Highways and Traffic Representation Panel

2. DUKE STREET - PROPOSED CYCLE SCHEME (Pages 1 - 12)

SUBJECT:	DUKE STREET, BIRKENHEAD – PROPOSED CYCLE SCHEME
WARD/S AFFECTED:	BIDSTON & ST. JAMES WARDS
REPORT OF:	ROB CLIFFORD SENIOR MANAGER (COMMISSIONING) BUSINESS SERVICES
RESPONSIBLE PORTFOLIO HOLDER:	COUNCILLOR STUART WHITTINGHAM
KEY DECISION?	NO

COMMITTEE PLAN 1 OF 2
 DUKE STREET, BIRKENHEAD
 PARK ROAD NORTH TO CORPORATION ROAD
 BIDSTON & ST JAMES WARD

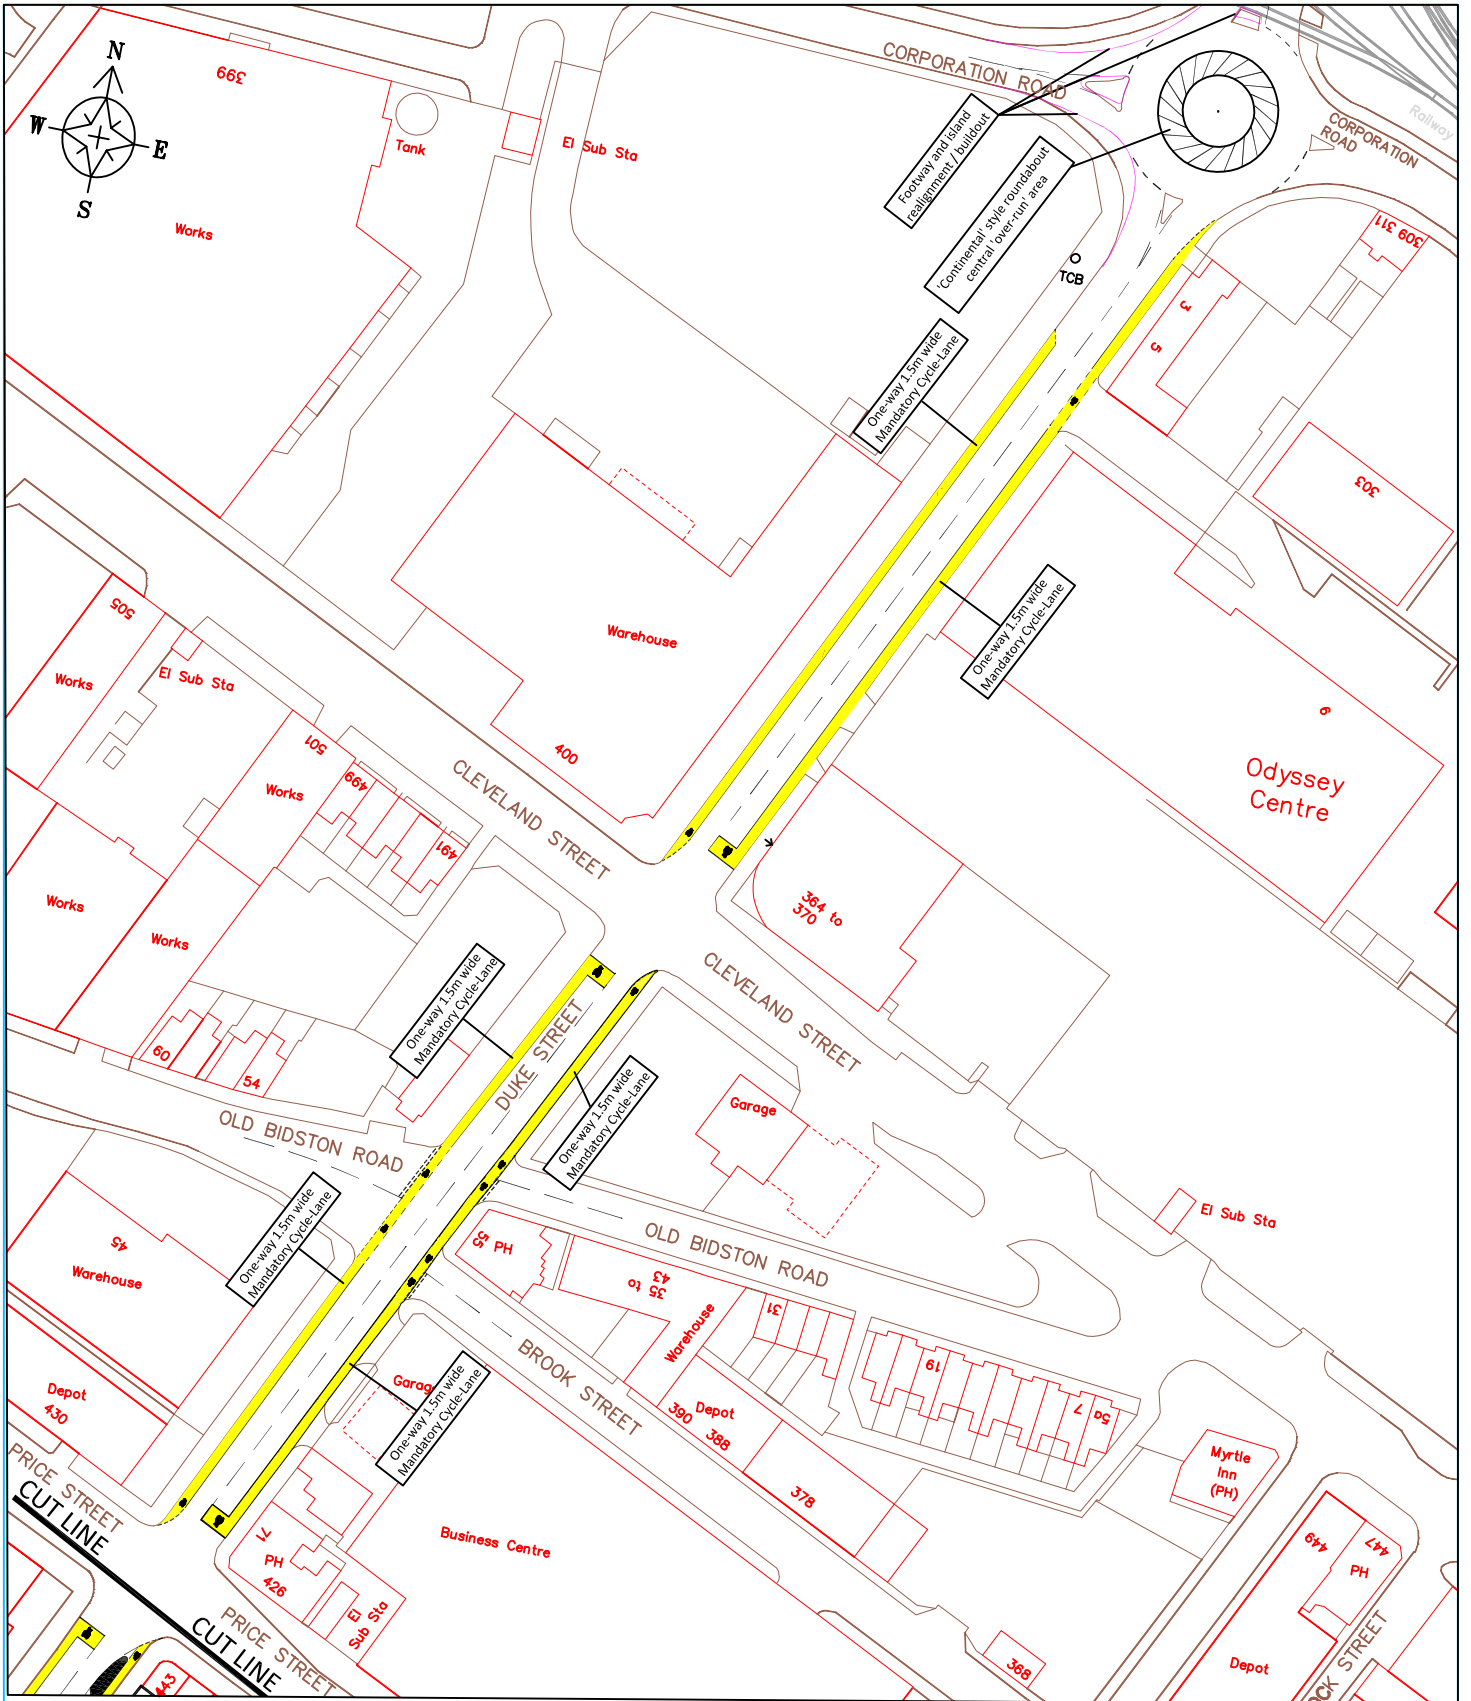
- 4.4 The petitioners are concerned that the parking bay would be moved further away from their homes into a busier, narrower traffic lane. They feel their safety would be at risk and their cars would be damaged by passing traffic.

- 4.5 The petitioners suggest that traders along Duke Street would not be able to load and unload goods, for example the newly relocated post office would struggle due to the proposed mandatory cycleway location.

- 4.6 The petitioners are concerned the level of emissions will increase due to the proposals as they believe traffic will become more congested due to the proposals.

- 4.7 The petitioners are also concerned that Duke Street is a busy and heavily trafficked road carrying articulated vehicles to and from the roll on roll off ferry, the docks, the Kingsway Tunnel, Liscard / Seacombe and the M53 with four crossroads / junctions between Park Road North and Corporation Road and has suggested that roads parallel to Duke Street (Livingstone Street and Cavendish Street).should be considered as being more appropriate to routes for cyclists as they are quiet residential roads with considerably less traffic than Duke Street.

- 4.8 The individual objector is also concerned that the proposed removal of 5 on-street parking spaces adjacent to the Council owned former (now closed) adult training centre will create further problems for residents who sometimes have difficulty finding on-street parking close to their homes. The Panel should be aware that a petition was received in October from residents of Asquith Avenue requesting residents parking to alleviate the problems faced by residents as a result of all day commuter parking. The same objector is also concerned that the cycleway positioned behind the 'floating' parking bay will increase the risk of damage to their cars from cyclists using the lane.

Current lane widths along Duke Street could be considered as being overly generous in places for a one lane carriageway (varying between 4.75m and 6.15m wide). The proposed scheme will result in lane widths (excluding any on-road cycle-lanes) along the full length of Duke Street varying between 3.25m and 4.65m (in excess of the 3m minimum recommended lane width for a 30mph classified distributor road carrying buses and heavy goods vehicles). Reducing excessive lane widths is also proven to have a calming effect on traffic speeds with drivers taking more care.

On-street parking bays along Duke Street are currently defined by road markings alone. The proposed scheme will provide a kerbed build-out on the approach to each new (floating) parking bay, protecting resident's vehicles and reducing the likelihood of conflict from passing traffic.

The junction of Duke Street / Price Street and Duke Street / Cleveland Street will be reduced to one lane on the Duke Street approach to the traffic signals. This will eliminate the possibility of two lanes of traffic trying to merge into one over a very short distance and (together with the presence of the proposed kerb build-outs as shown on plan DC/0247/100 and DC/0248/100) further reduce any risk of residents parked vehicles being hit. Detailed turning counts and computerised signal capacity calculations confirm that there is ample spare capacity to accommodate these minor physical alterations

As a result of objectors concerns, alterations have been made to the length of mandatory cycleway from the bus stop up to the signalised junction at Park Road North outside these businesses. It is proposed that this section of on-road cycleway will now take the form of an advisory lane and thus will not legally affect the ability to load and unload but casual parking would remain as being not permissible

Detailed turning counts and computerised signal capacity calculations have been undertaken at each of the signalised junctions along Duke Street. The results of this analysis confirm that there is spare capacity to deal with the minor signal timing and physical alterations required at each signalised junction and the minor changes in lane widths along the length of Duke Street.

The proposed scheme will however greatly improve safety for cyclists using the Duke Street link between Wallasey and Birkenhead, providing innovative ('floating') split-level cycle-ways physically segregated from traffic (passing behind parking bays), advanced stop lines at signalised junctions, on-road mandatory cycle-lanes and alterations at the Corporation Road roundabout to make it more 'cycle-friendly' in terms of geometry. It would be completely unreasonable and unrealistic to expect cyclists to undertake a major diversion away from the most obvious route along Duke Street to follow an alternative that would not only be considerably longer and inconvenient, but would also require a number of un-catered for and less safe turning movements to eventually re-join the route further ahead.

The positioning of the cyclist to the nearside of the ('floating') parking bays removes the cyclist from the risks associated with sharing a live traffic lane. In line with current design standards, each (one-way) cycleway will be 1.5m wide with a 0.6m 'safety' hard-standing buffer-zone between the cycle lane and the (floating) parking bay provided to minimise risk to cyclists from passenger side doors opening.
